January 19, 2023

**Re: SCAQMD Proposed Amended Rule 1178, Further Reductions of VOC Emissions from Storage Tanks at Petroleum Facilities – WSPA Comments on the Cost-Effectiveness Analysis**

**Figure 1. Results of the Cost-Effectiveness Analysis**

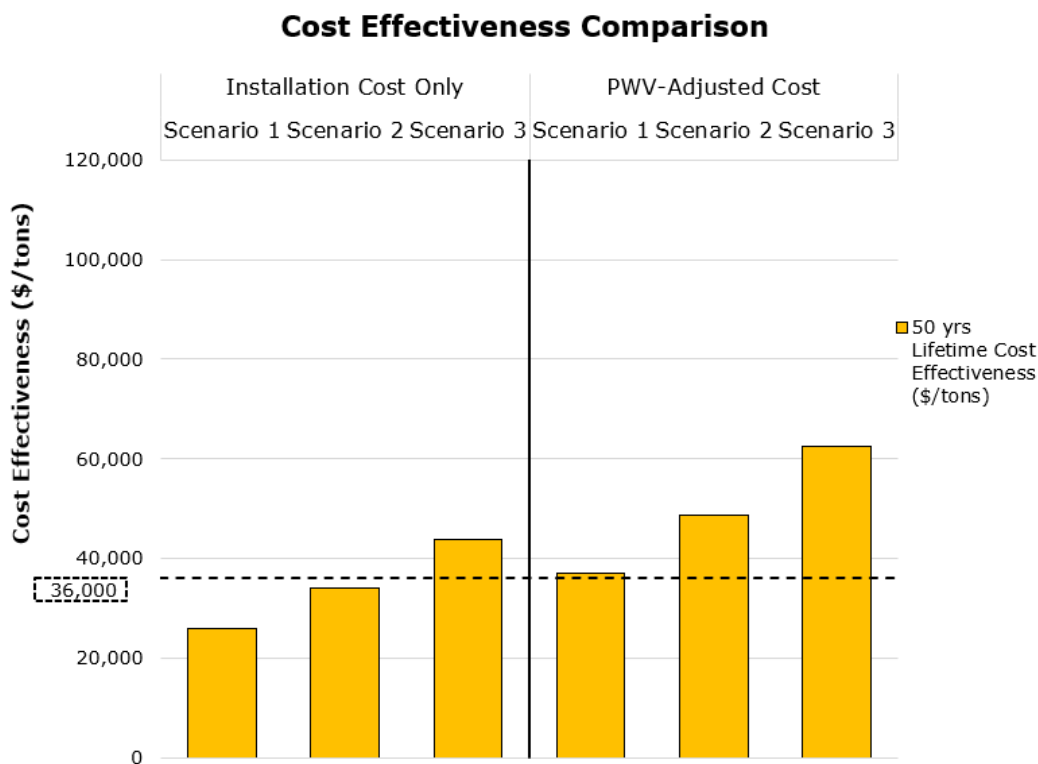
As shown in Figure 1, Ramboll’s analysis demonstrates that under most cost estimation scenarios, the proposed doming controls would actually exceed the cost-effectiveness threshold of \$36,000 per ton of VOC emissions reduced. It is important to note the following:

- SCAQMD costs presented in Working Group Meeting #6 assume no operation and maintenance costs over the lifetime of the equipment. As presented in the bars on the right side of Figure 1, if annual operation and maintenance costs are incorporated, none of the scenarios are cost-effective.
- The data presented in Figure 1 is based on District’s estimated emission reductions which assume all materials stored in the tanks have a Reid Vapor Pressure (RVP) of

8.19. Because SCAQMD has not grouped the tanks based on class and category, it is not possible to know whether doming of the tanks would be cost-effective. Given the potential overstatement of emission reductions discussed in Comment #2, it is likely that doming of tanks would be significantly less cost-effective than presented in Figure 1.

- There will be additional costs associated with tanks being out of service during the retrofiting projects, which were not considered in any of these scenarios.

Given the issues with the cost-effectiveness calculations presented by the District, WSPA believes the SCAQMD needs to reevaluate cost-effectiveness to incorporate operations and maintenance costs and create classes and categories suitable to the materials handled in the tanks.

**Figure 3. Results of the Cost-Effectiveness Analysis – Useful Life Comparison**

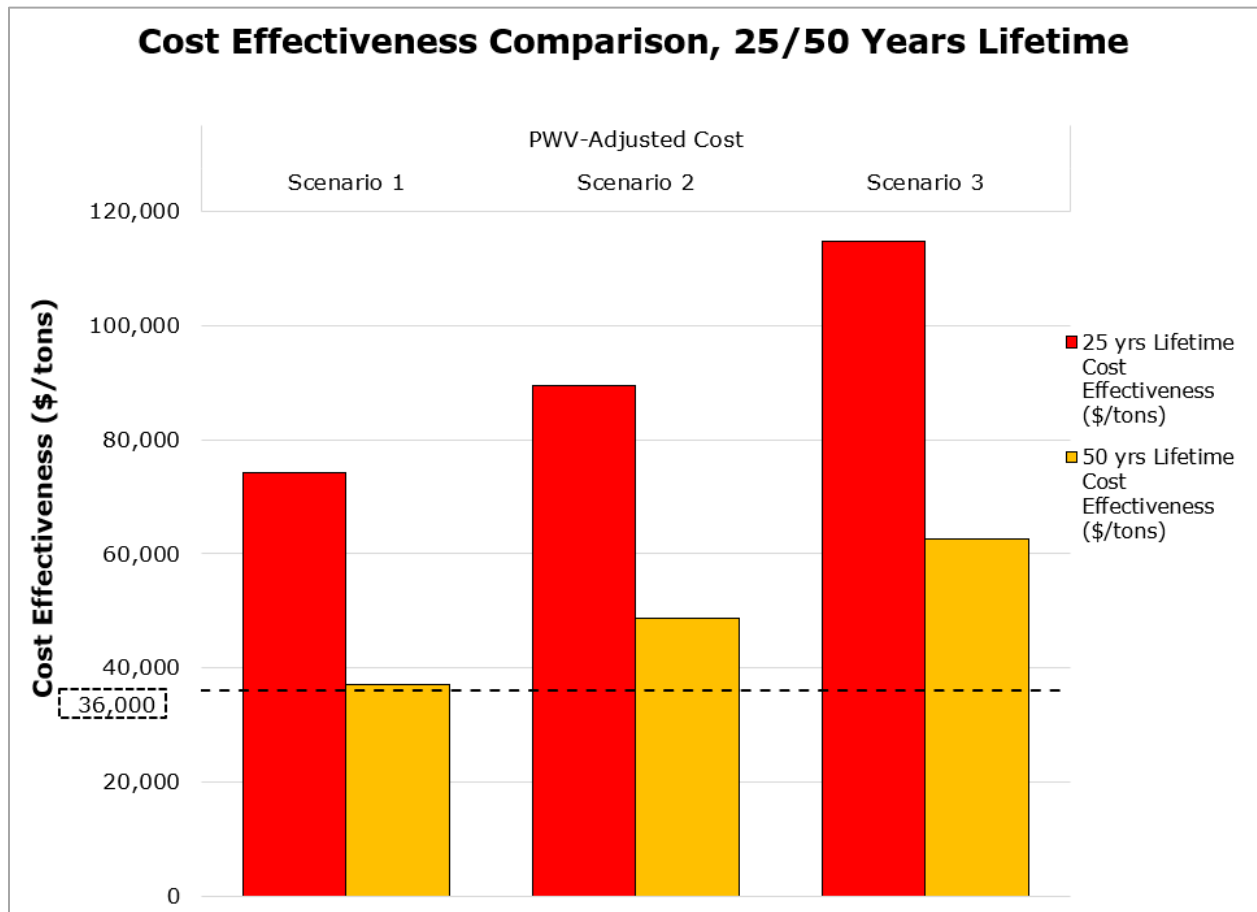
Ramboll considered cost-effectiveness (as discussed in Comment #1) using the District’s more typical 25-year useful life assumption (which would extend to 2048). This was done for the three scenarios discussed above. The results are summarized in Figure 3 below and compared against the \$36,000 cost-effectiveness threshold.

As shown in Figure 3, none of the scenarios would be below the cost-effectiveness threshold (for PWV-adjusted estimates) using the 25-year useful life assumption. The District needs to re-analyze cost effectiveness considering a more reasonable useful life.
